Z-59  
(2008)

Preliminary Plan

# Interstate West Retail Center

Cobb County, Georgia Land Lots 613, 614, 583, & 584, 18th District, 2nd Section

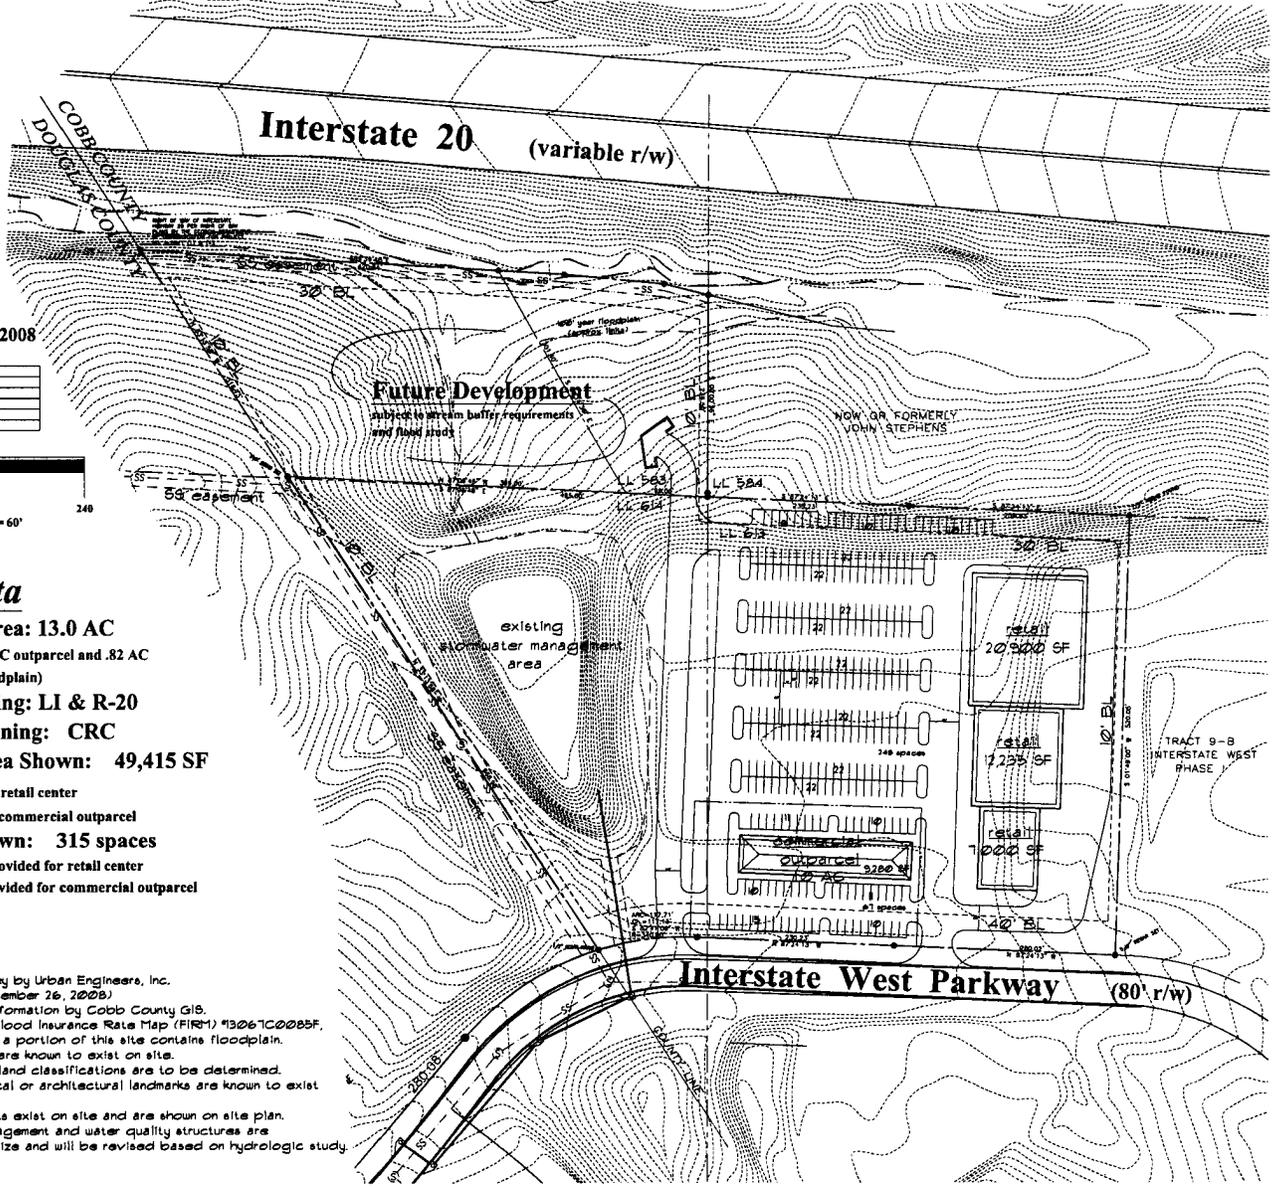
- Provide comprehensive hydrology/stormwater controls to include development of out parcels.
- Submit all proposed site improvements to Plan Review.
- Any **spring activity** uncovered must be addressed by a qualified geotechnical engineer (PE).
- Structural fill \_\_\_\_\_ must be placed under the direction of a qualified registered Georgia geotechnical engineer (PE).
- Existing facility.
- Project must comply with the Water Quality requirements of the CWA-NPDES-NPS Permit and County Water Quality Ordinance.
- Water Quality/Quantity contributions of the existing lake/pond on site must be continued as baseline conditions into proposed project.
- Calculate and provide % impervious of project site.
- Revisit design; reduce pavement area to reduce runoff and pollution.

- No Stormwater controls shown \_\_\_\_\_
- Copy of survey is not current – Additional comments may be forthcoming when current site conditions are exposed.
- No site improvements showing on exhibit.

1. There is an existing master detention facility located on this parcel. Adequate capacity to accommodate the proposed retail center must be verified at Plan Review. Any pond maintenance issues must also be identified and addressed.
2. The area designated for future development is encumbered by floodplain as well as stream buffers associated with Sybert Creek. The breach zone for the existing detention pond will also impact the development potential for this portion of the site. Any future development of this area must provide adequate conveyance for the master detention facility discharge as well as breach zone requirements. No net fill will be allowed in the floodplain.
